ADDENDUM #3

PROJECT: Rapid Valley Elementary School Addition and Remodel
DATE: March 16, 2026
BID DATE: March 19, 2026 at 2:00pm MST

PROJECT ADDENDUM NO. 03

ADDENDUM NO. 3 - MECHANICAL

DATE: **03.02.2026** SHEET NO:
PROJECT NO: **S111**
2025-198

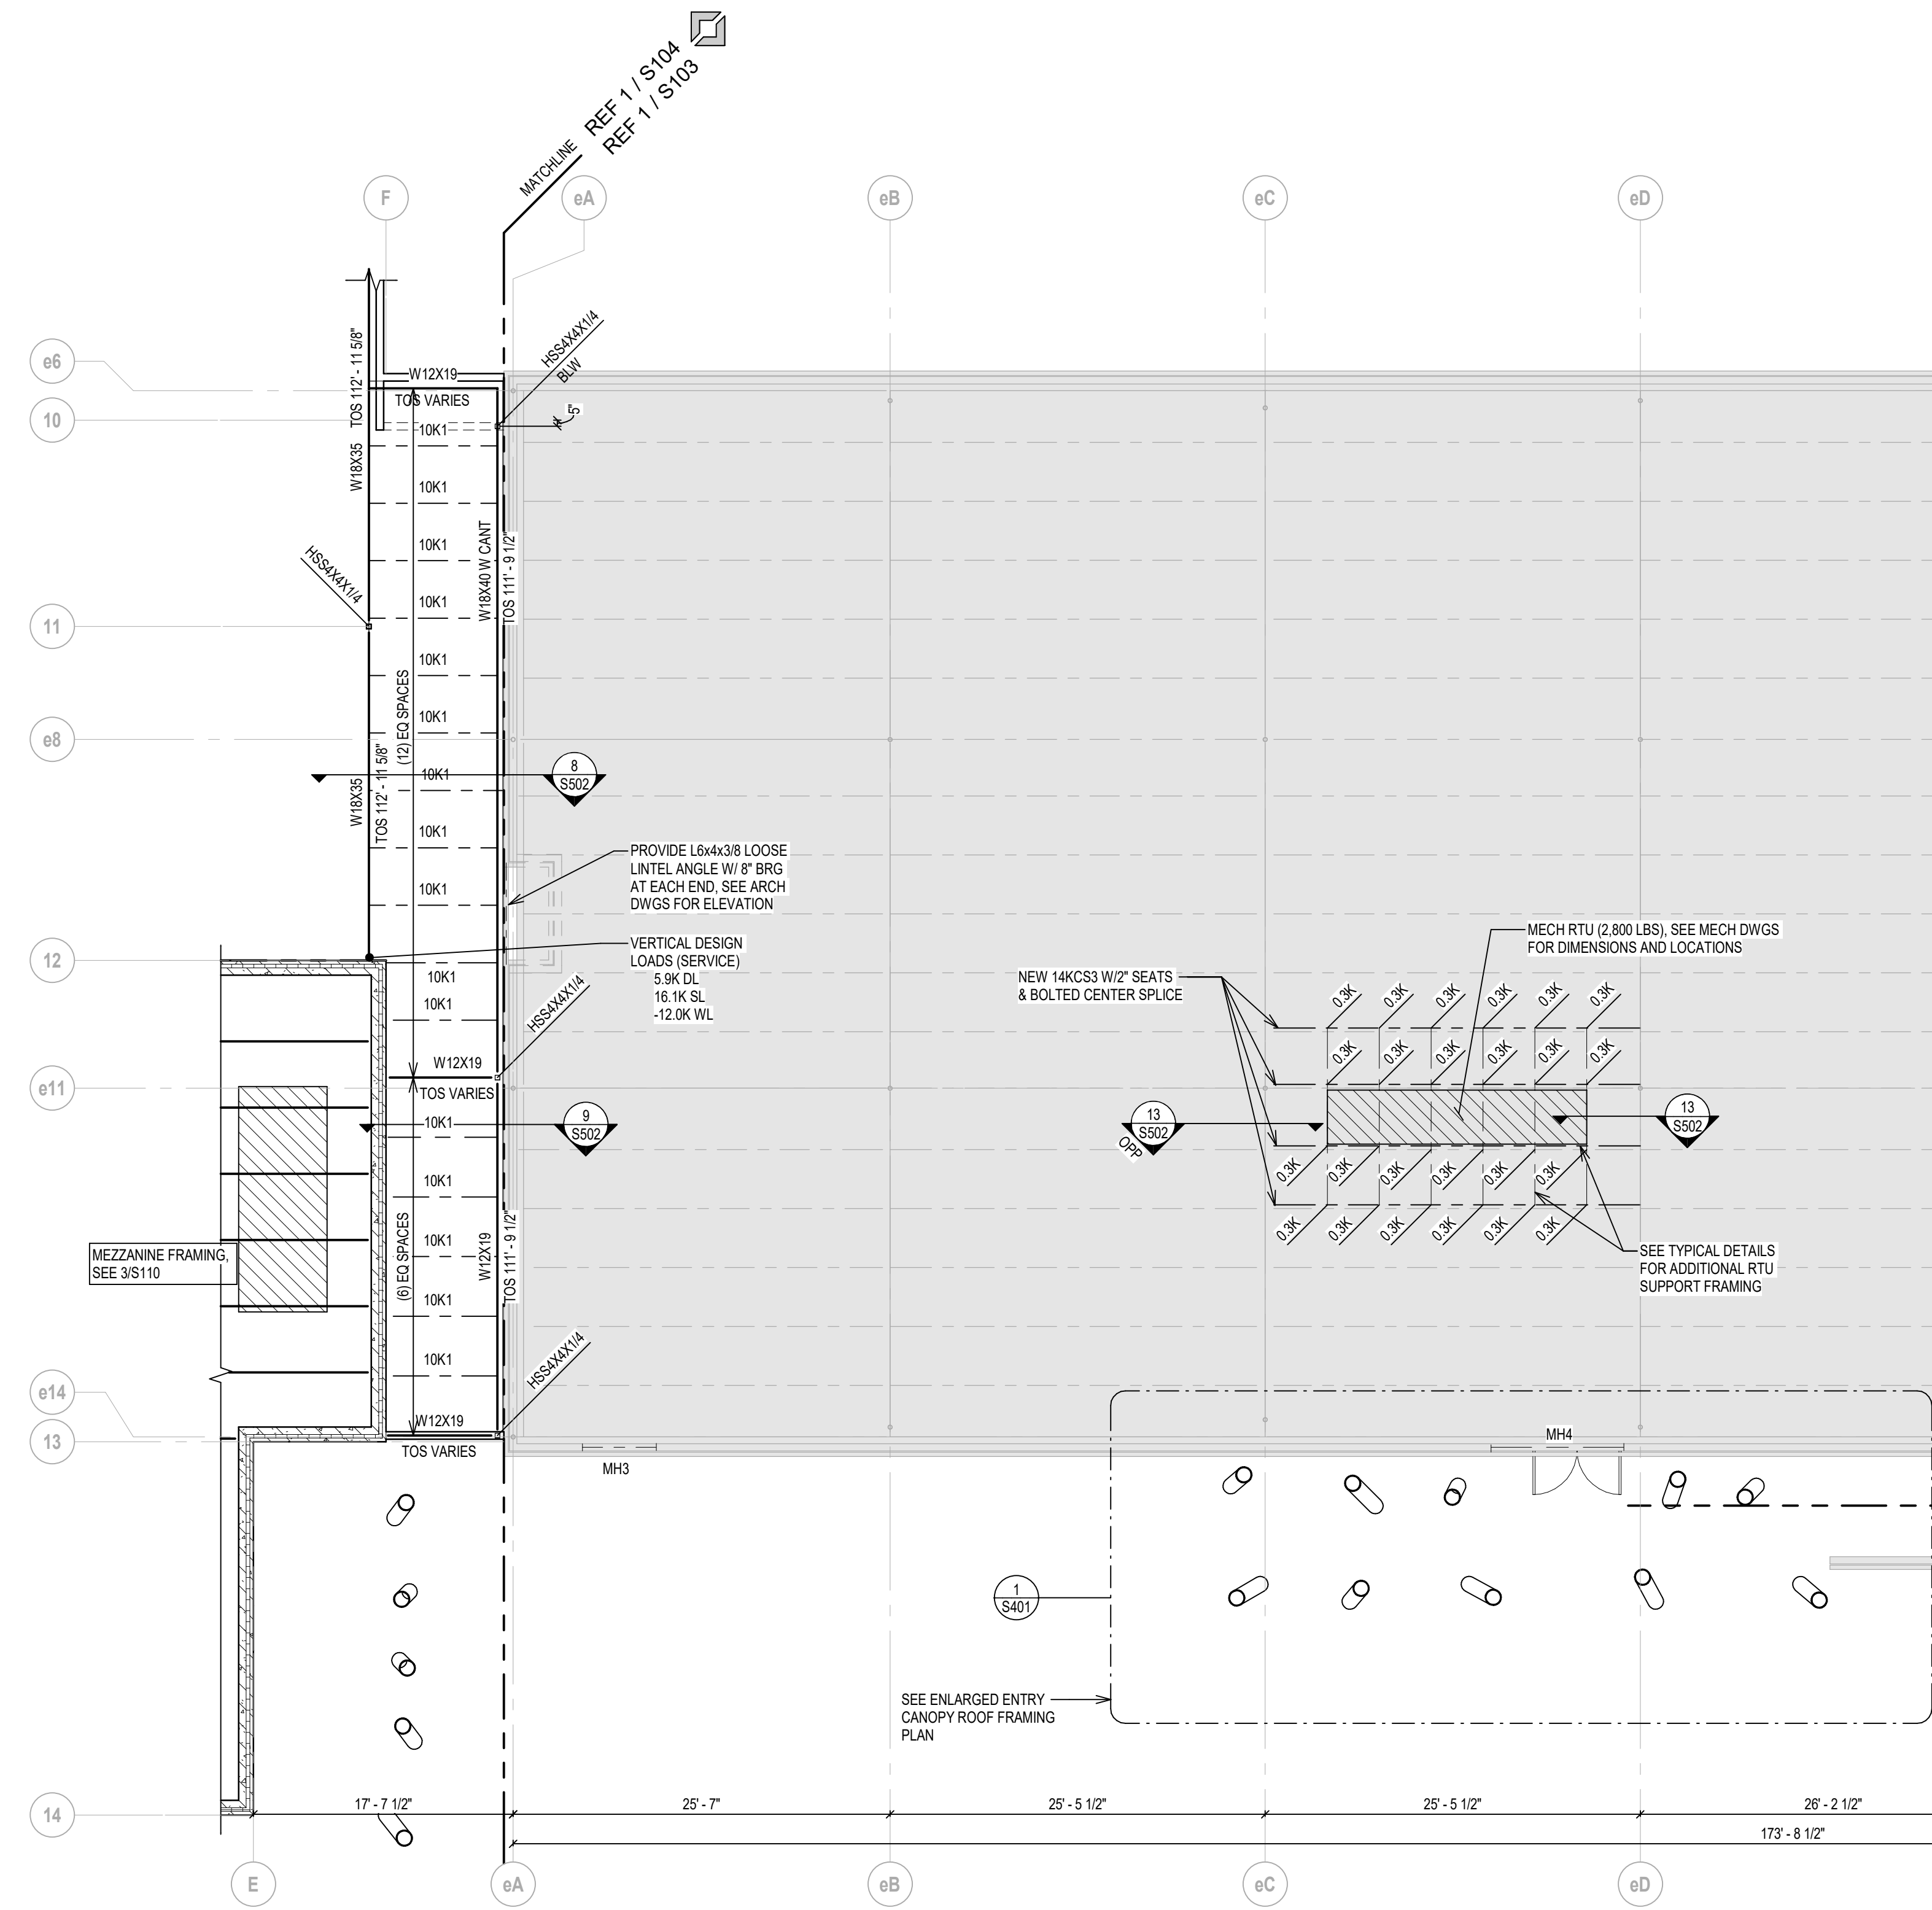
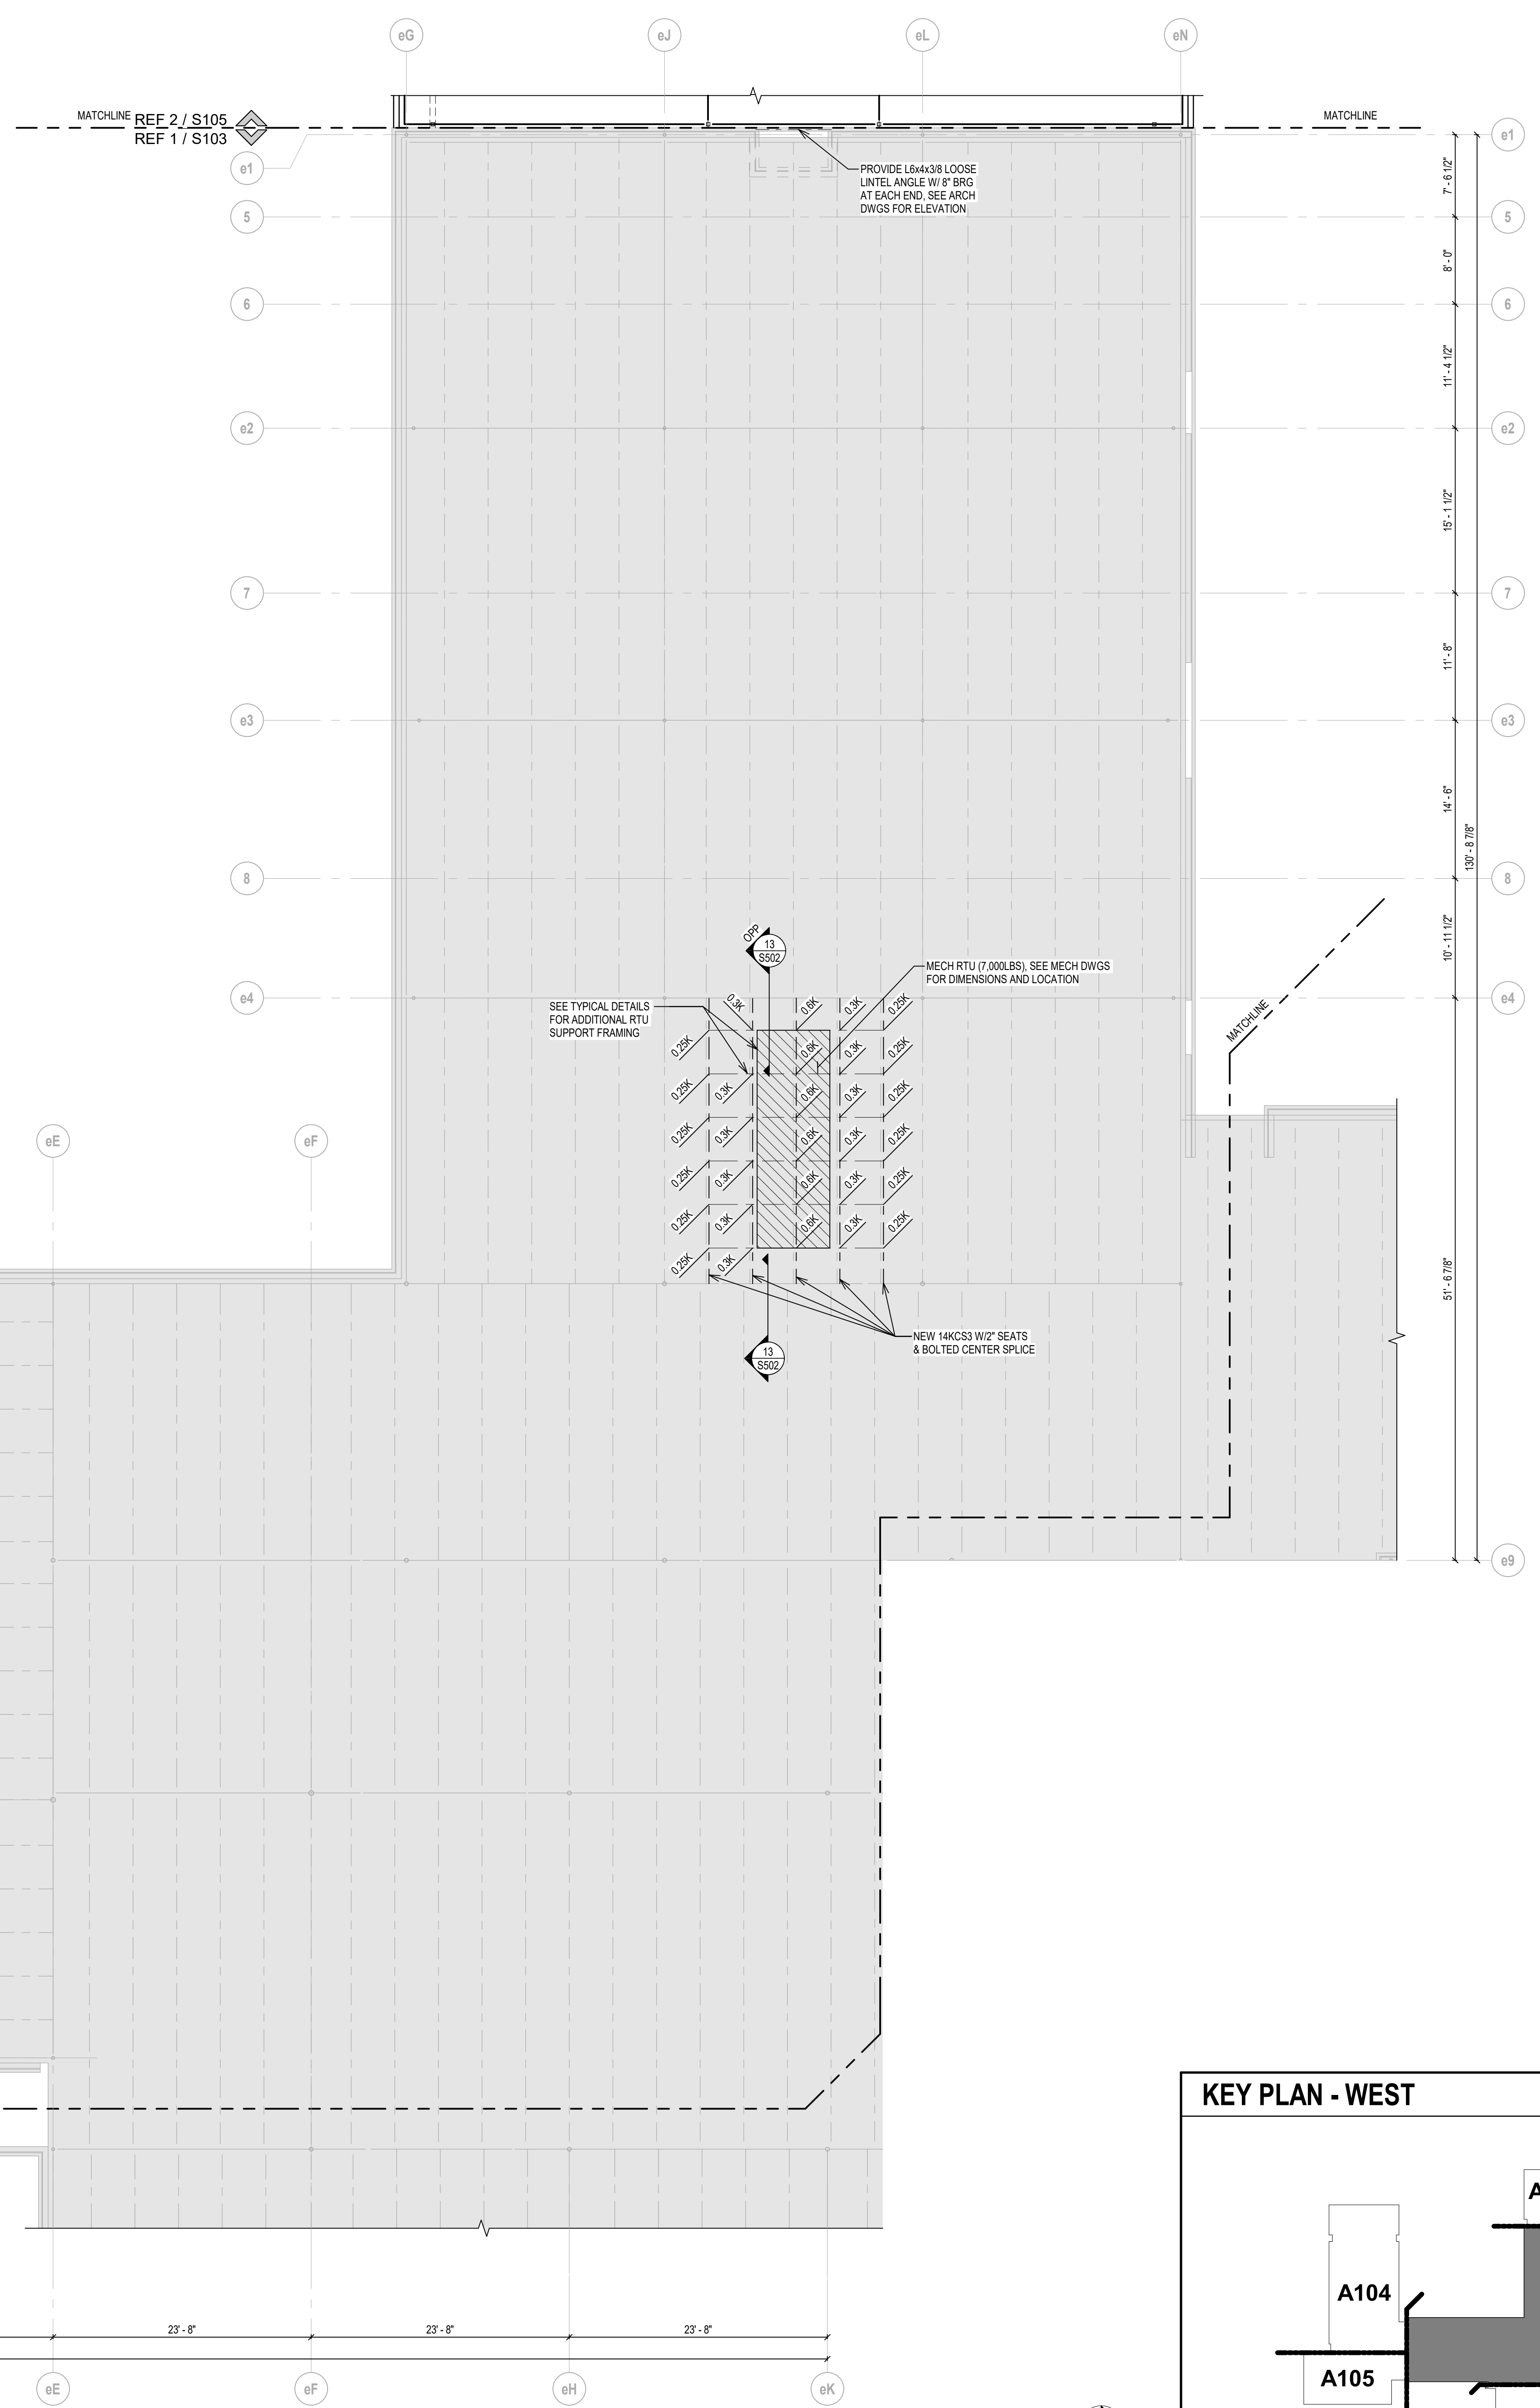
- Construction Documents
 - ◆ SHEET S105
 - i. Column along Gridline 1 between J & L was moved to Gridline J and additional column was added to Gridline L.
 - ◆ SHEET S109
 - i. Roof Plan Notes – Entry Canopy was added to the steel decking note.
 - ◆ SHEET S110
 - i. Column along Gridline 1 between J & L was moved to Gridline J and additional column was added to Gridline L.
 - ii. Beam line along gridline 1 was adjusted.
 - iii. Roof Plan Notes – Entry Canopy was added to the steel decking note.
 - ◆ SHEET S111
 - i. Roof Plan Notes – Entry Canopy was added to the steel decking note.
